BOSTON EDISON COMPANY  
GENERAL OFFICES 800 BOYLSTON STREET  
BOSTON, MASSACHUSETTS 02199

BECo. Ltr. #76-53

Docket No. 50-293  
License No. DPR-35

ADDITIONAL INFORMATION ON SINGLE LOOP OPERATION

TABLE 1

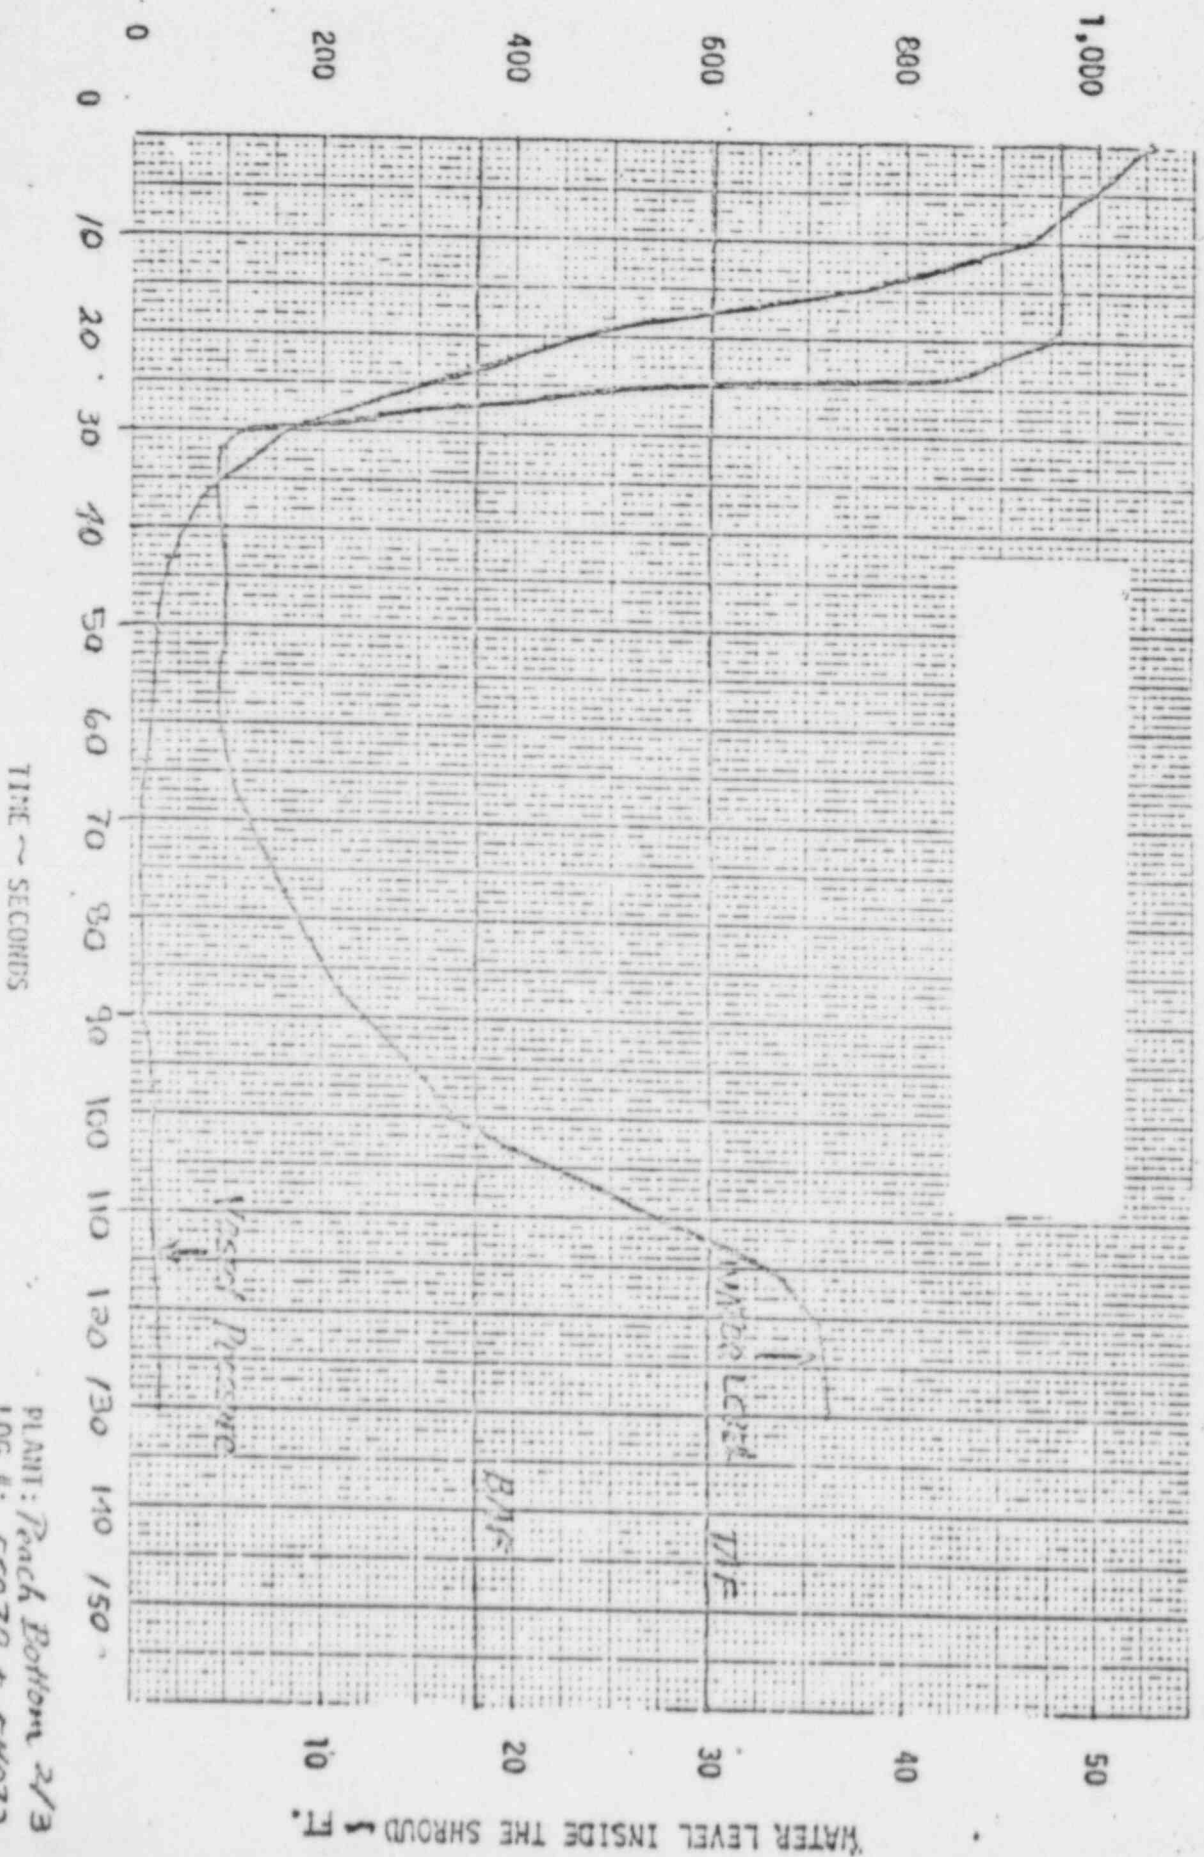
2. Provide a set of calculations as a function of core life for Pilgrim to justify selection of the MAPLGR curve. The above parameters should be provided in graphical form.

The MAPLGR as a function of exposure is obtained by multiplying the MAPLGR for two-loop operation (which varies with exposure) by the MAPLGR Reduction Factor as explained in the Pilgrim Single Loop Operation License Submittal, which contains the justification for this approach. For each of the points

shown on Figure 1 of the submittal, a set of sensitivity calculations were made of the MAPLHGR multiplier with respect to exposure (see Table 1) and the most conservative MAPLHGR reduction factor was selected. For Pilgrim (point 5 of Figure 1) the most conservative factor occurs at 17,500 MWD/t exposure. It is common practice for G.E. to truncate the MAPLHGR reduction factor to two significant figures. The value of 0.867 is the calculated reduction factor at 17,500 MWD/t for Pilgrim and is shown as such to be consistent with the initial submittal.

<u>Exposure</u> <u>MWD/t</u>	<u>MAPLHGR Reduction</u> <u>Factor</u>
200	.91
1000	.91
5000	.91
10000	.90
17500	.867
25000	.91
30000	.91

FIGURE 1

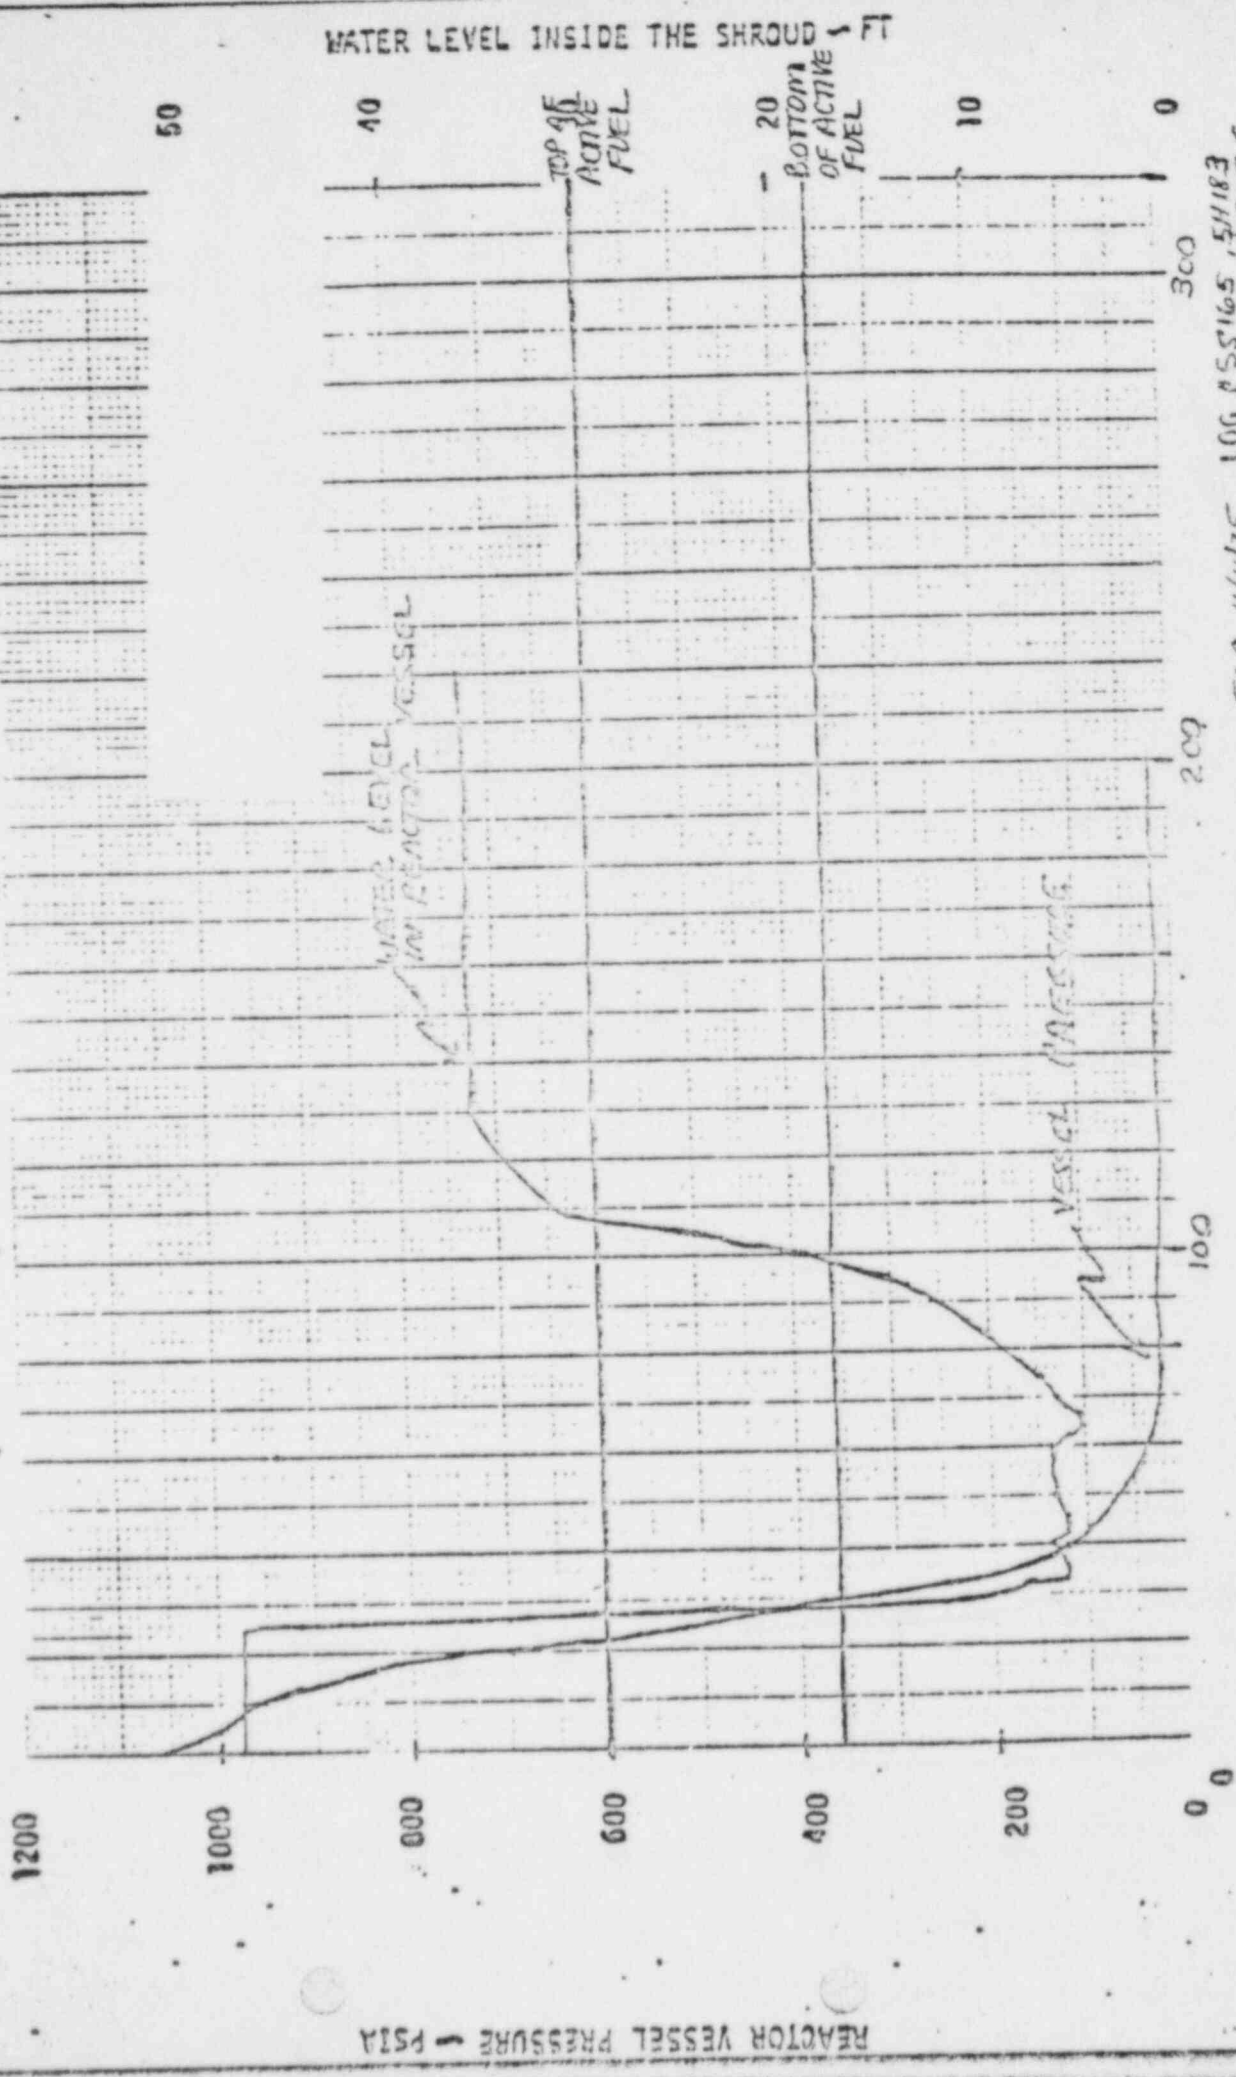
1. Furnish, in graphical form, the results of a complete DBA LOCA calculation for Pilgrim when operating in the single recirculation loop mode. Also provide the results of a complete break spectrum analysis to demonstrate that the DBA is the limiting case. The parameters of interest are as follows:

Peak Clad Temperature (ruptured and unruptured nodes)  
Reactor Vessel Pressure  
Water Level Inside the Shroud  
Thermal Power  
Heat Transfer Coefficients

The requested information is shown in Figures 1-6 for Peach Bottom 2/3 and in Figures 7-9 for Pilgrim.
